City of Woodburn
Community Development

Memorandum

Date: January 31, 2023
To: Melissa Gitt, Building Official
Cc: Alyssa Nichols, Permit Technician
Dago Garcia, P.E., City Engineer
Darren Hendren, Hendren Construction LLC
Randy Saunders, RSS Architecture
Phil Alfieri, ALF/Temple, LLC
From: Colin Cortes, AICP, CNU-A, Senior Planner *CC*
Subject: **Building permits 971-22-001059-STR through 1062-STR Cleveland Crossing Apts. (f.k.a. Templeton Apts.) Planning Division review [b]**

- Marked landscape plan excerpt in green 1
- Marked landscape plan excerpt in green 2

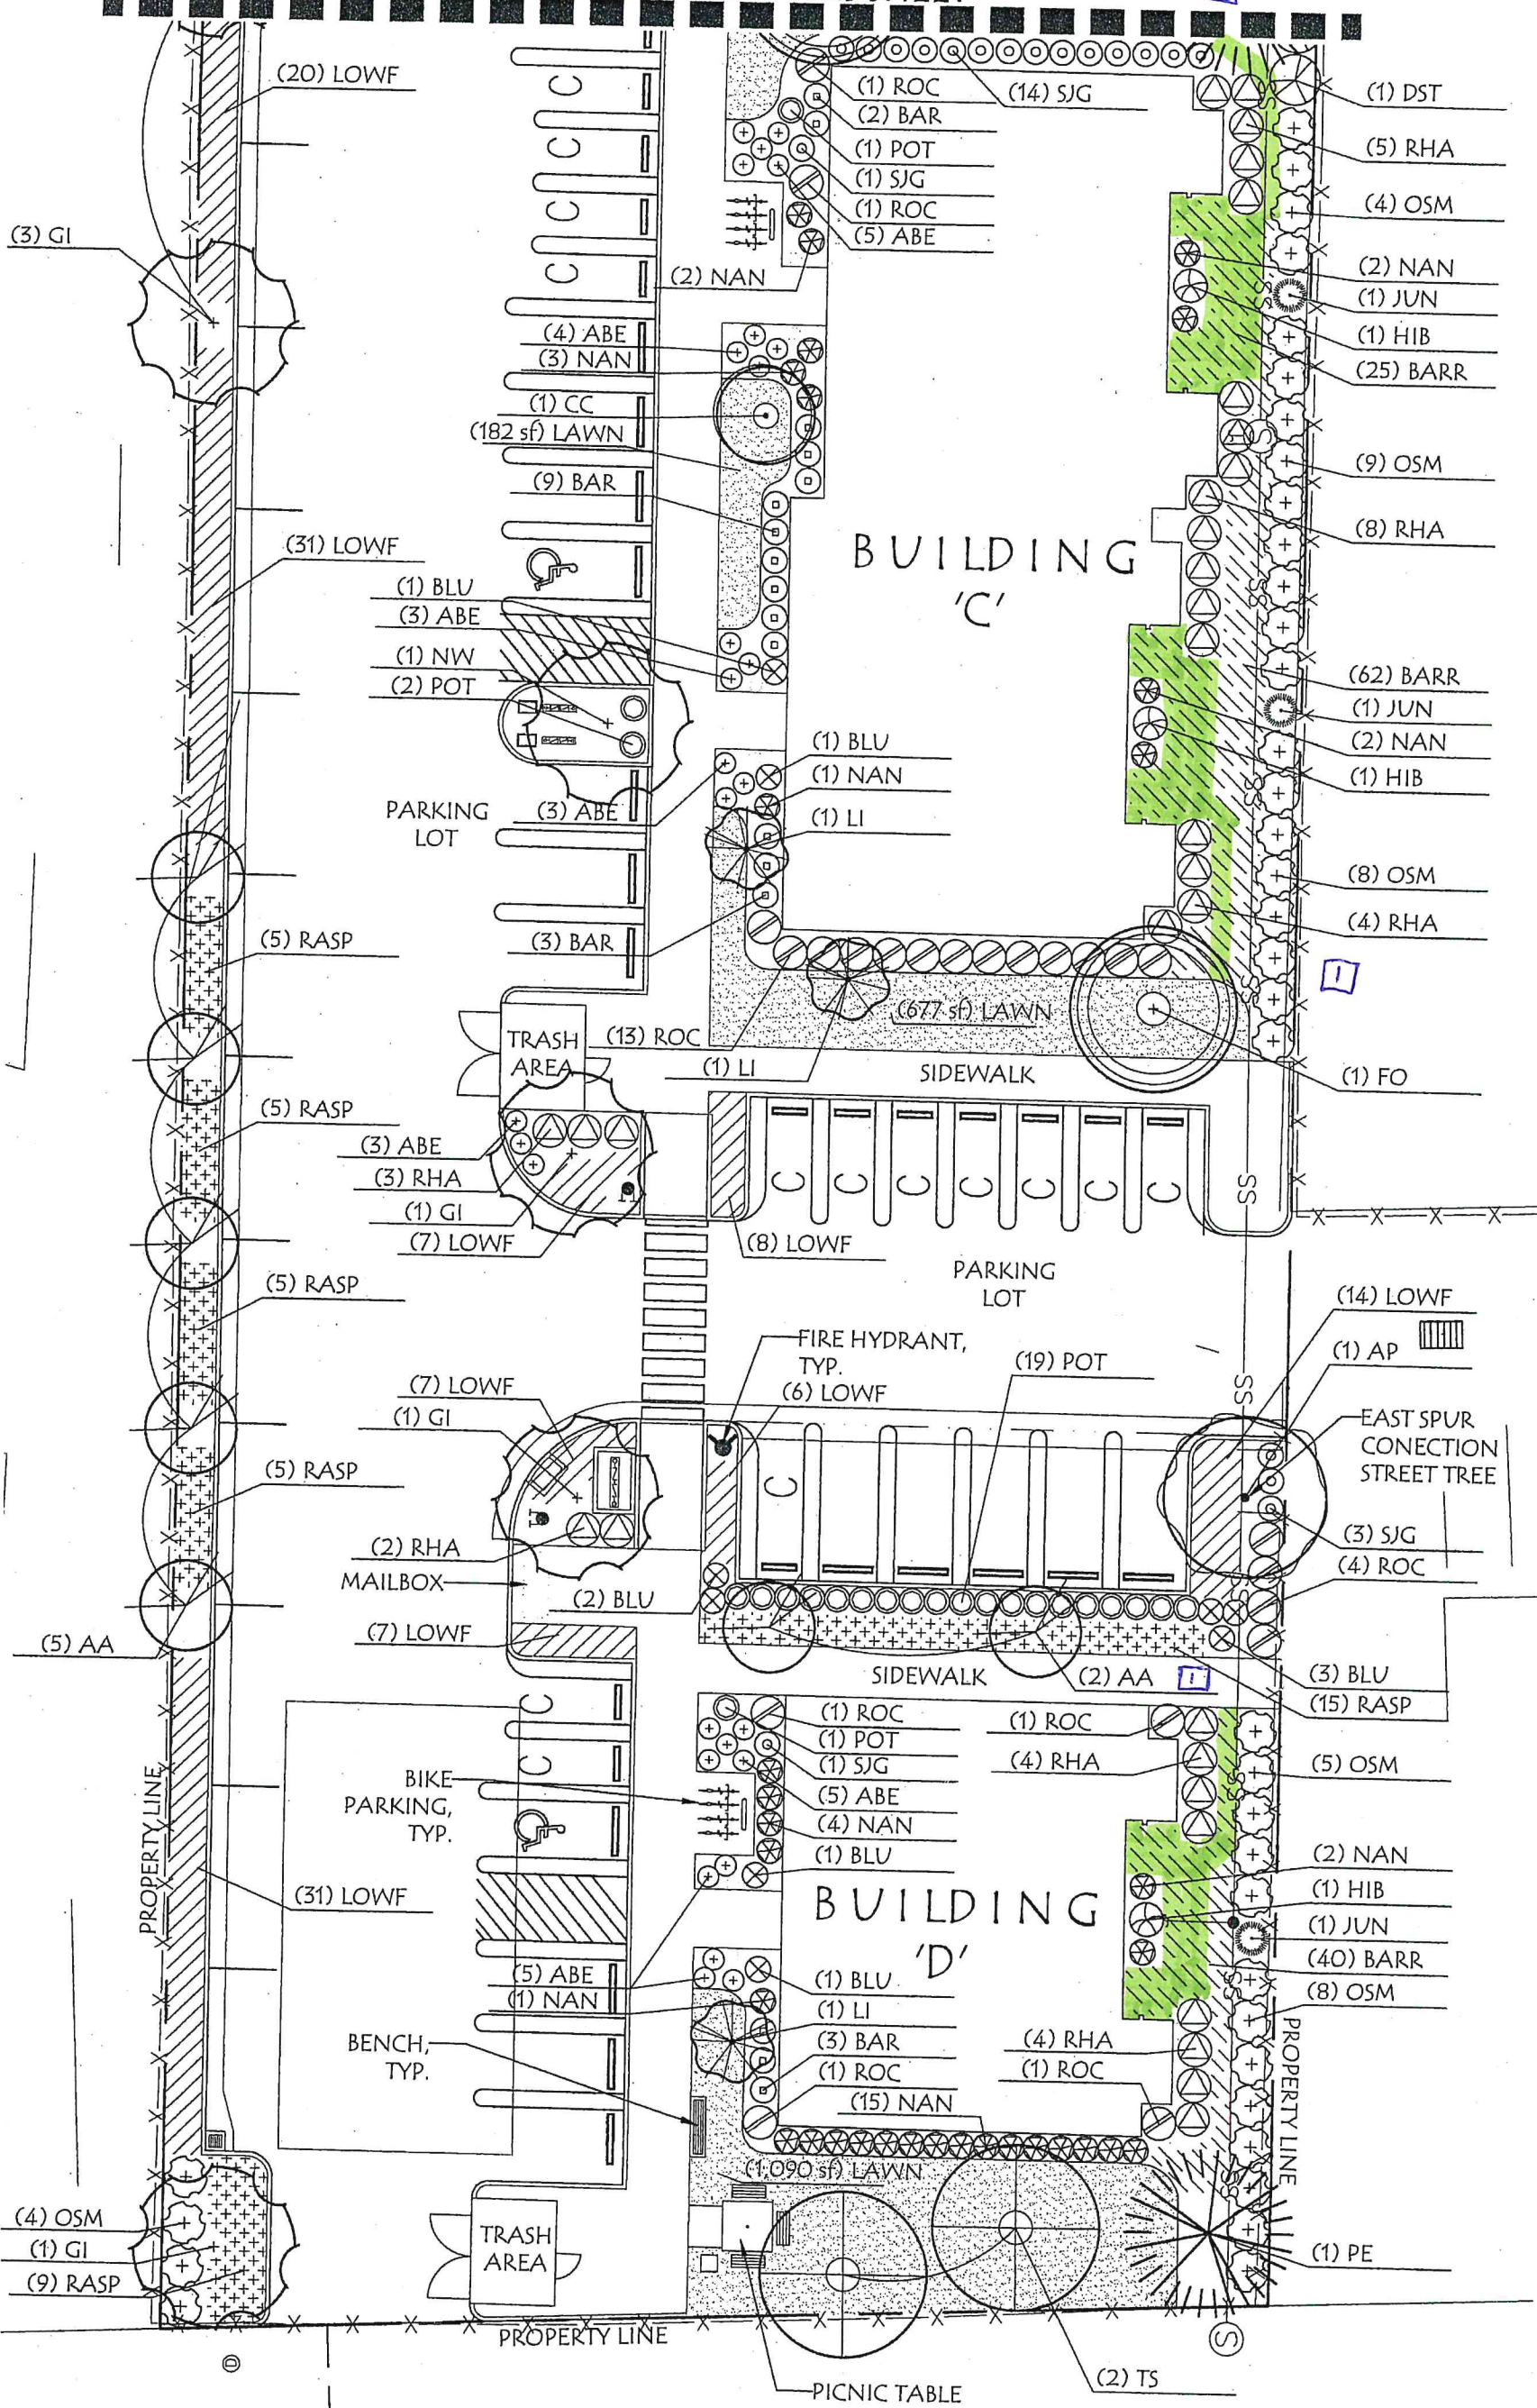
LL. Landscaping: Revise per the attached mark-ups to have more lawn area instead of shrubbery at the east rear of buildings near patios.

Legend:
Lawn

Note []:
Min 3-foot wide strips
